Certificate of Substantial Completion

PROJECT: *(name and address)*
New Pool at Zemurray Park
Hammond, LA

CITY OF HAMMOND
ZEMURRAY PARK POOL
 September 11, 2019
 GGB Project 1624

Mechanical Punchlist Report

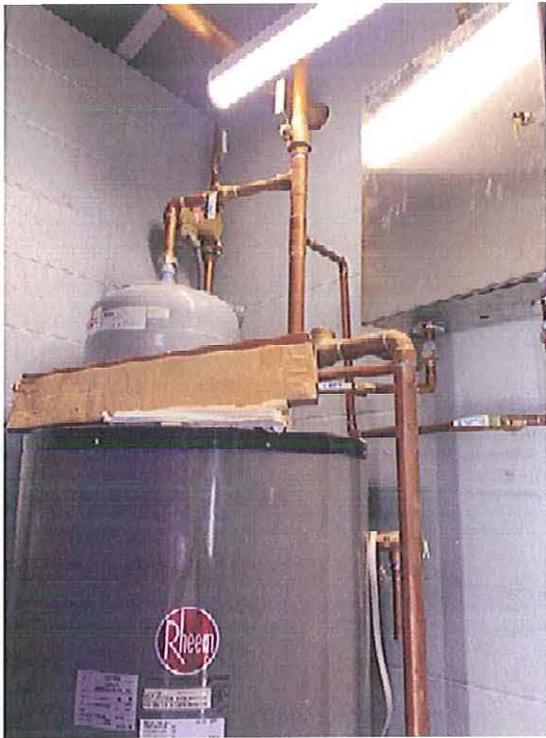
| Deficient Items: Total \$22,000 | <ul style="list-style-type: none"> • \$1,000 • \$500 • \$300 • \$1,500 • \$800 • \$1,500 • \$4,000 • \$100 • \$1,200 • \$3,000 • \$100 • \$500 • \$1,500 • \$500 • \$900 • \$500 • \$200 | <ul style="list-style-type: none"> • Patch exposed holes in block wall around shower units, multiple locations. See picture #1. • Provide insulation, piping labels, & directional arrows on all domestic water piping located in Water Heater room 18. See pictures #3, & #4. • Provide supports for thermal expansion tank. Current supporting not acceptable. See pictures #3, & #4. • Electric water heater (WH-1) not operational at time of inspection. • Instantaneous water heater (WH-2) to serve Lavatory located in Equipment room 12 not operational at time of inspection. • Instantaneous water heater (WH-2) not installed within shroud located under wall mounted lavatory as indicated on drawings. See picture #7. • Sanitary vent piping stubbed out in room at time of inspection, typical of 4 locations. Contractor to extend vent piping up through roof in Changing rooms 1, 8, 10, & Equipment room 12. See pictures #11, #16, #20, & #21. • Clean paint and debris off of all hose bibbs throughout project. See picture #6. • Electric water cooler located on exterior of building installed over hose bibb at time of inspection. Fixture to be installed not to conflict with use of hose bibb. See picture #14. • Sump pump located in pit of Equipment room 12 not installed at time of inspection. See picture #10. • Drain located at base of emergency shower/eyewash station in equipment room 12 currently installed facing wall. Drain to be installed to face floor drain. See picture #8. • Provide hub/funnel on storm drain piping stub-up in Equipment room 12 to prevent backsplash as indicated on pool equipment drawings. See picture #9. • Complete installation of exhaust fan 13 located in Chemical room 13. See picture #12. • Complete insulating exposed domestic water piping within Changing rooms. See pictures #16, & #21. • Contractor to provide and install smooth surface aluminum jacketing on exposed domestic water piping routed over Check-in canopy. Jacketing to be painted to match adjacent tin roof/walls. See picture #13. • Contractor to seal around all brick vents throughout project and provide insect screens as specified on Mechanical drawings. See picture #2. • Contractor to seal around thru-the-wall heat pump unit (PTAC-1) located in Office room 11. See pictures #5, #18, & #19. |

5.

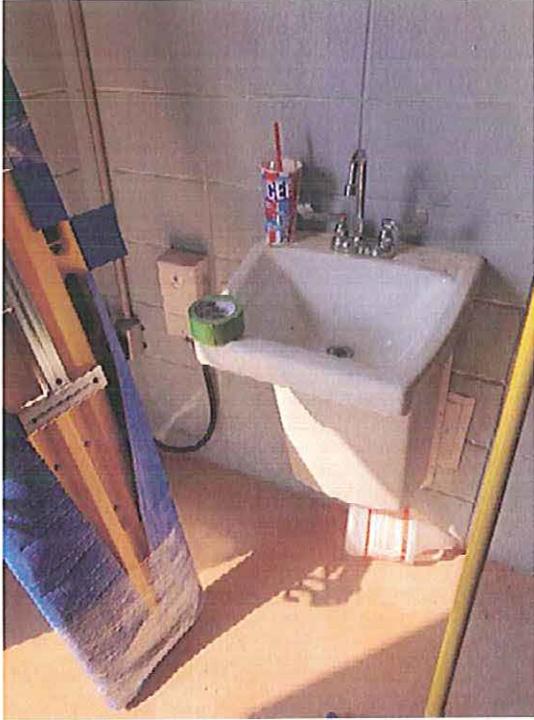
| | <ul style="list-style-type: none"> • \$1,000 • \$2,000 • \$500 • \$200 • \$200 | <ul style="list-style-type: none"> • PTAC-1 located in Office room 11 not operating at time of inspection. See picture #5. • Route drainage piping from reduced pressure back flow preventer located in Equipment room 12 thru block wall, down to sump pit at bottom of pool pit. Seal piping penetration thru block wall. • Provide supports for back flow preventer located in Equipment room 12. Current supports not acceptable. • Provide caulking around base of all plumbing fixtures throughout project. • Clean dirt/debris & protective taping off of all floor drain strainers throughout project. |
